COMMONWEALTH OF KENTUCKY
BEFORE THE PUBLIC SERVICE COMMISSION

ELECTRONIC APPLICATION OF LOUISVILLE)	
GAS AND ELECTRIC COMPANY FOR)	
APPROVAL OF ITS 2020 COMPLIANCE PLAN)	CASE NO. 2020-00061
FOR RECOVERY BY ENVIRONMENTAL)	
SURCHARGE)

RESPONSE OF
LOUISVILLE GAS AND ELECTRIC COMPANY
TO COMMISSION STAFF'S POST-HEARING REQUEST FOR INFORMATION
DATED SEPTEMBER 11, 2020

FILED: SEPTEMBER 18, 2020

Figure 1: Range of Capital Construction Costs (Source: NREL 2019 ATB)

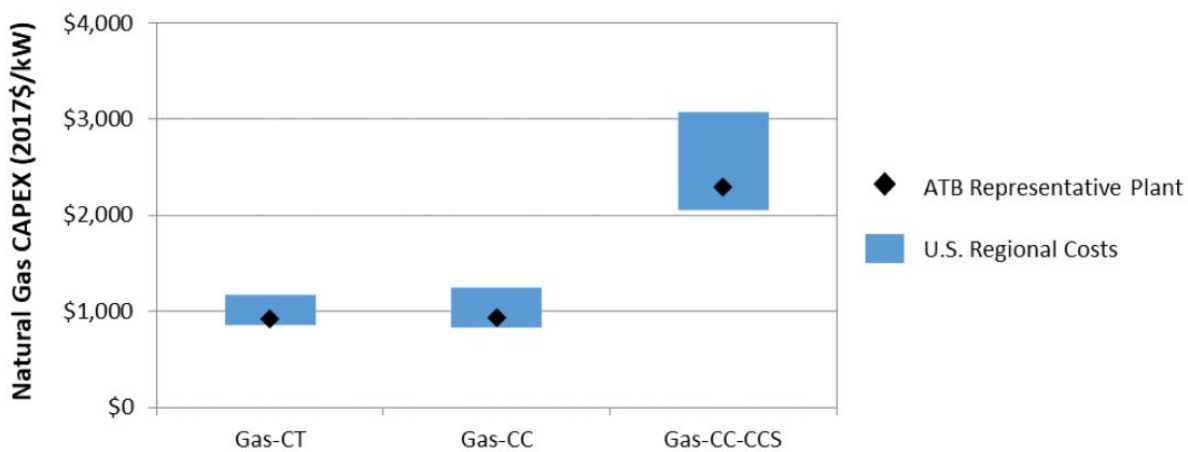
- c. Under the Replacement Generation Resources assumption, the cost for the Natural Gas Combined Cycle (NGCC) capacity should reflect the NGCC capacity cost based upon the 2019 Annual Technology Baseline from the National Renewable Energy Laboratory of \$887/kW.

The analysis that will be discussed below was updated to reflect National Renewable Energy Laboratory's 2019 Annual Technology Baseline ("NREL's 2019 ATB" or "2019 ATB") estimate

that a NGCC would cost \$887/kW (2020 in-service; 2017 dollars).⁷ Because cost of construction can vary, the chart below shows NREL's range of costs.⁸ Note that the \$887/kW is near the bottom of the range. It should also be noted that the capital cost assumption used in the Companies' analysis (\$1,044/kW in 2017 dollars for 2020 in-service) falls within the NREL range. Finally, please note NREL recently published its 2020 ATB, which shows the overnight capital cost for NGCC capacity at \$1,023/kW, which is indistinguishable from the Companies' assumption.⁹ Thus use of the NGCC construction costs at the lower range of the suggested database is now outdated.
